SENIORS APARTMENTS

BANK STREET AT DUN SKIPPER DRIVE

ISSUES		
No.	DESCRIPTION	DATE
1	SUBMISSION NO.1 FOR CITY REVIEW	2024-11-26
2	SUBMISSION NO.2 FOR CITY REVIEW	2025-02-18
3		
4

SHEET TITLE
GRADING PLAN

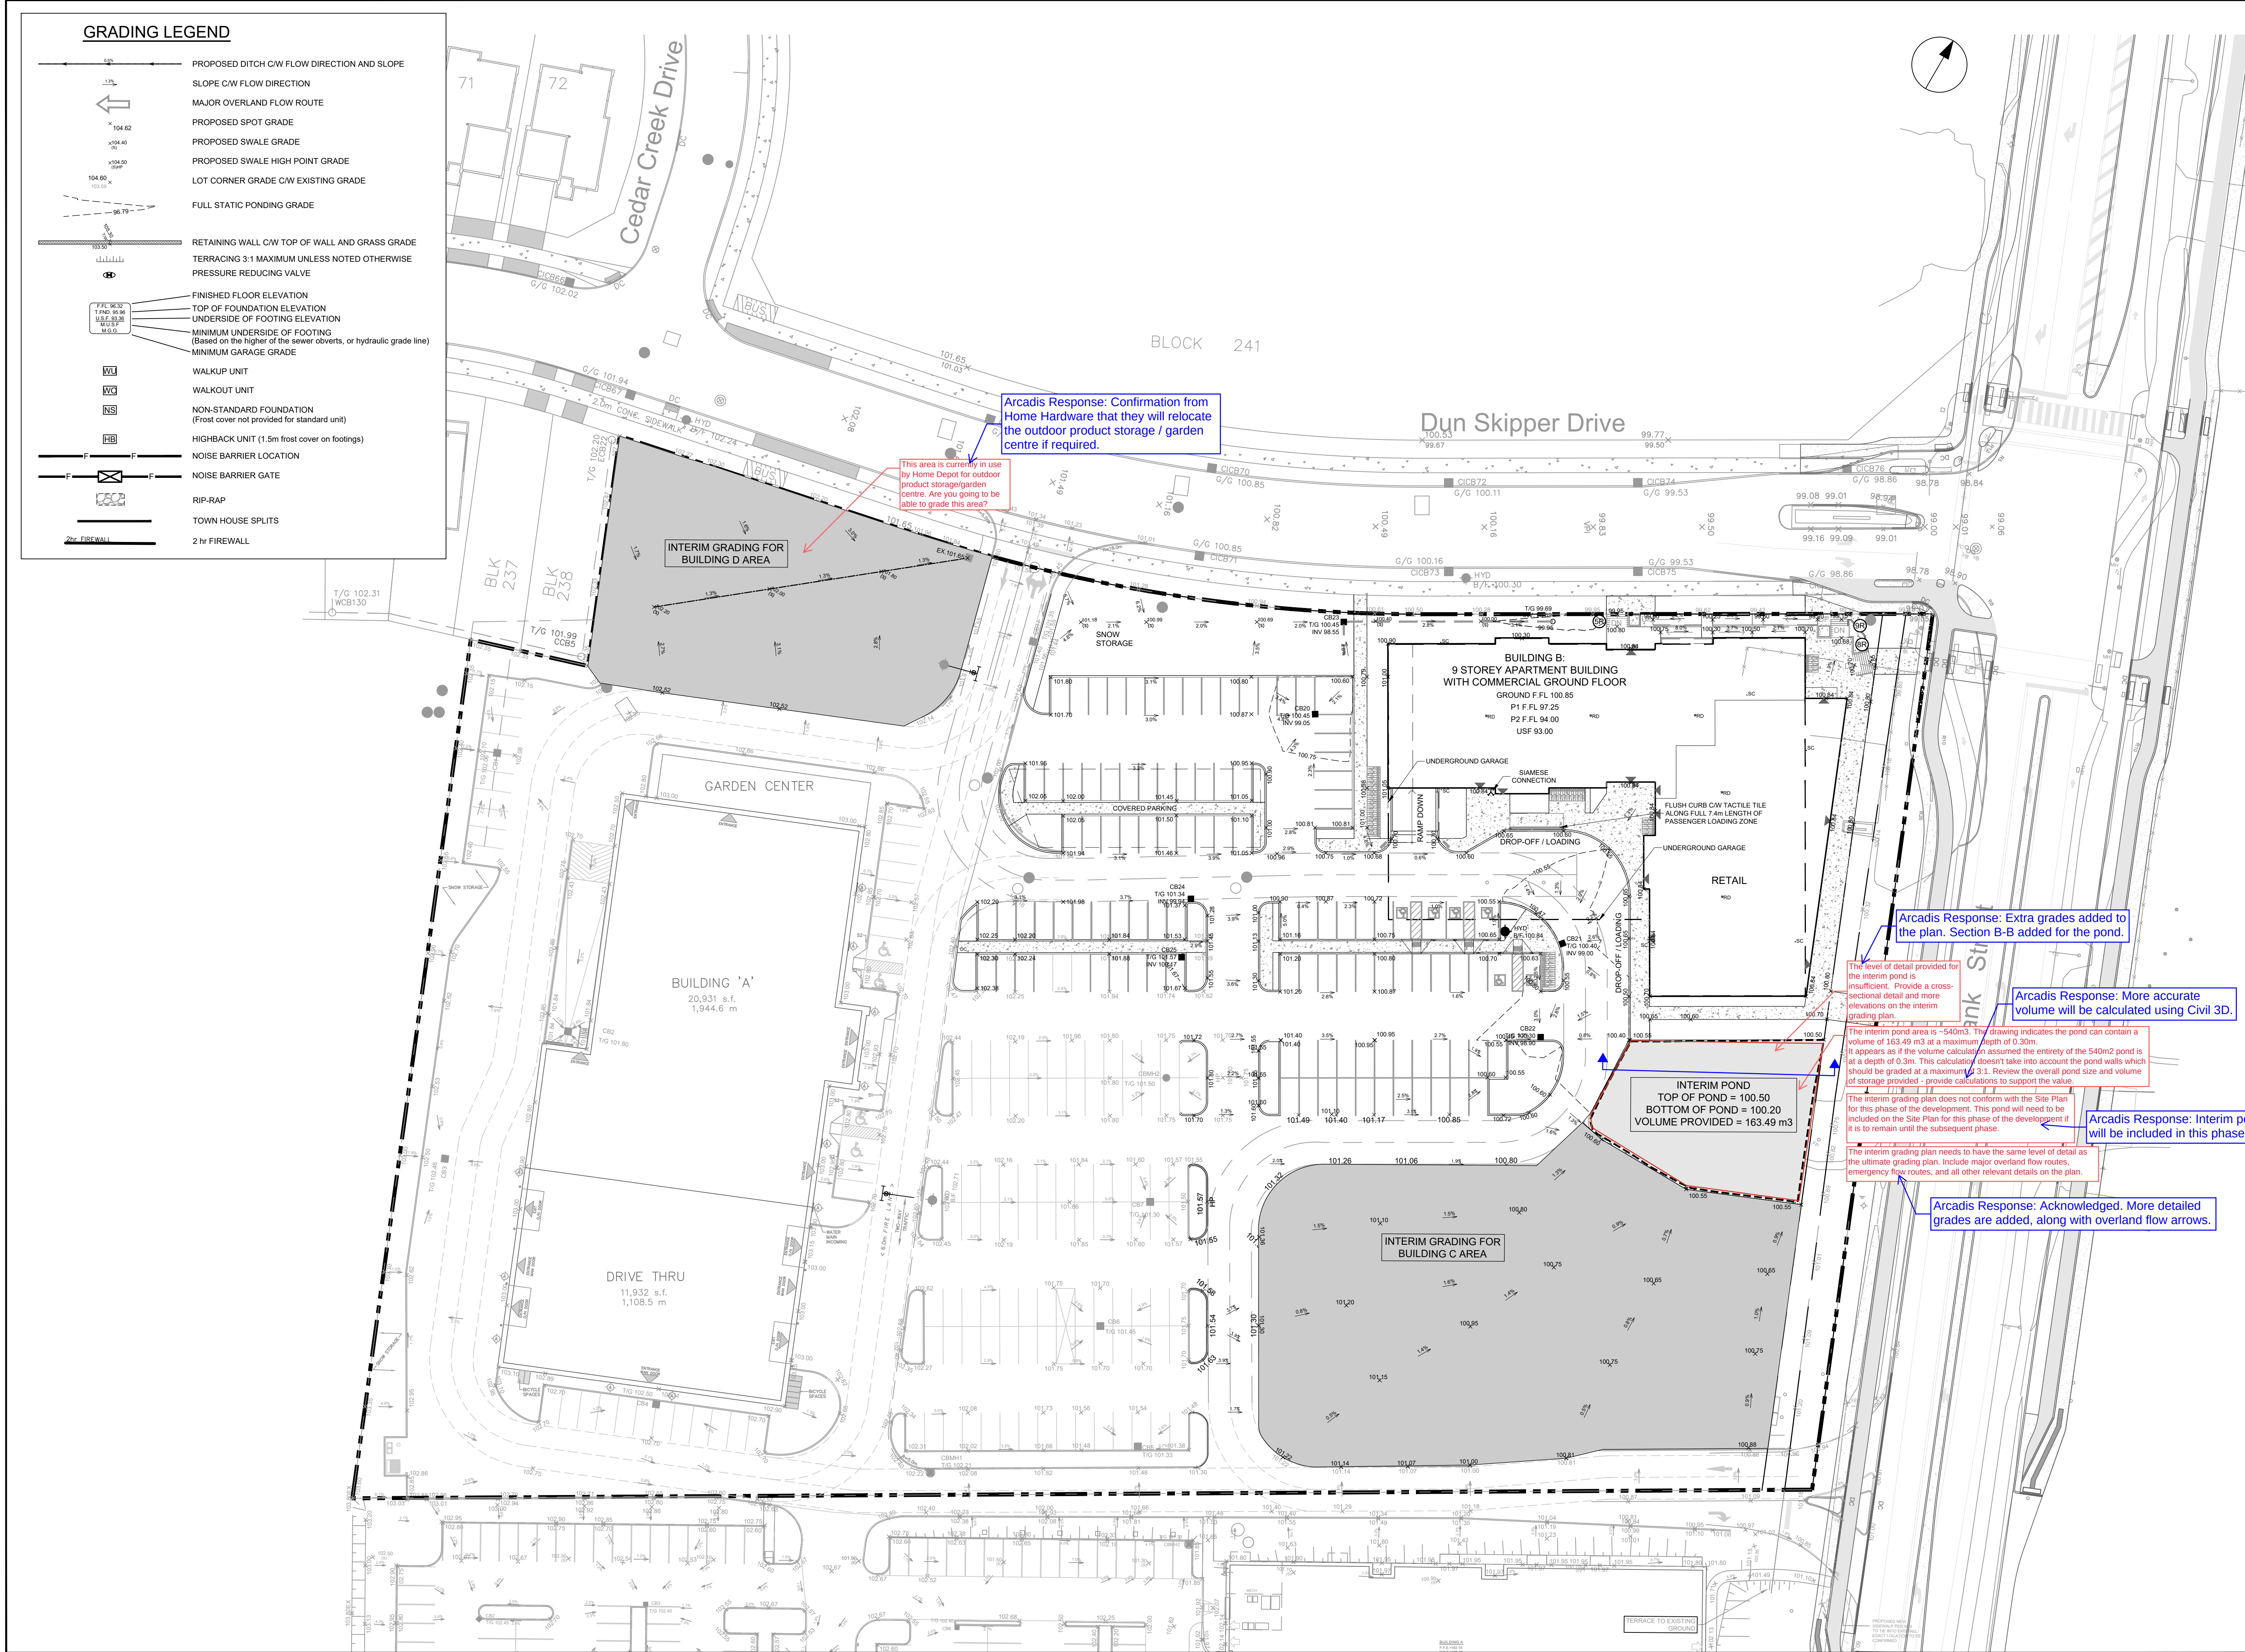
What is the height of the wall at the bottom of the stairs? Provide more information in this area. Note that walls greater than 1.0m in height, or retaining 2.0m of soil, will require a global stability analysis and detailed retaining wall drawings.

Arcadis Response: Wall height ranges from approximately 1m to 1.5m. (Stability analysis and wall design to be provided by geotechnical engineer)

STORM DRAINAGE AREA PLAN

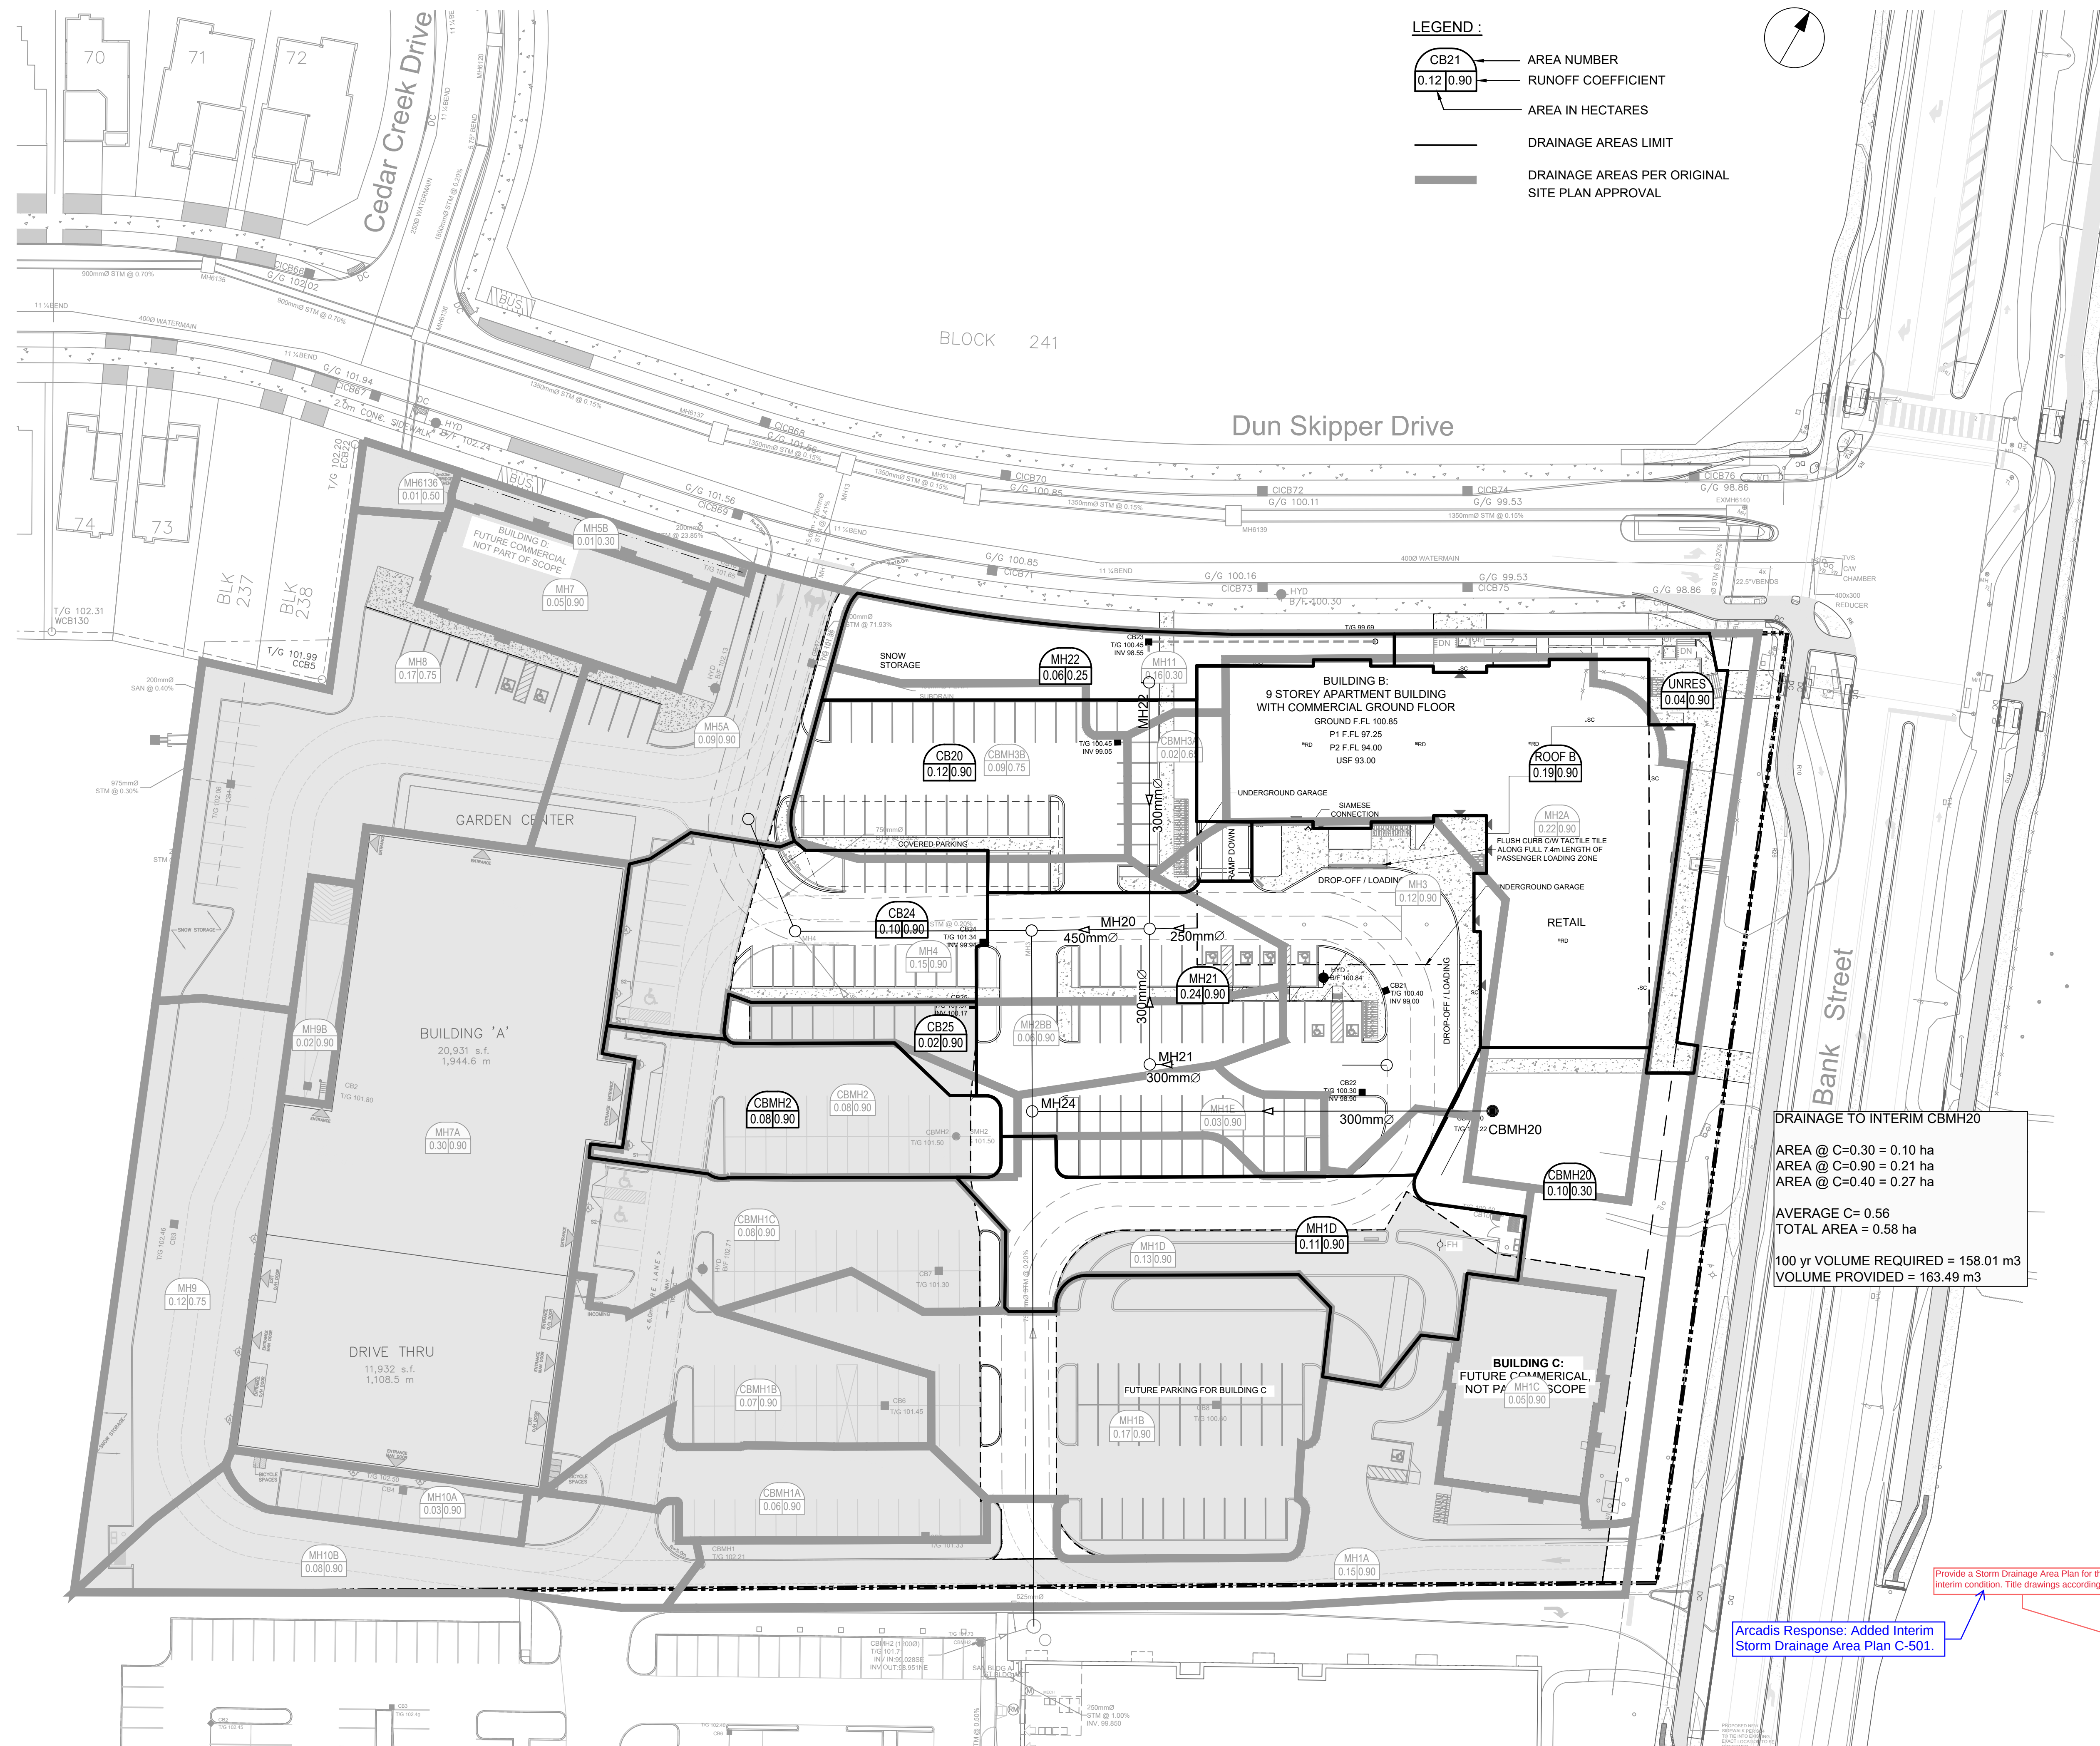
Provide a Storm Drainage Area Plan for the interim condition. Title drawings accordingly.

Arcadis Response: Added Interim Storm Drainage Area Plan C-501.
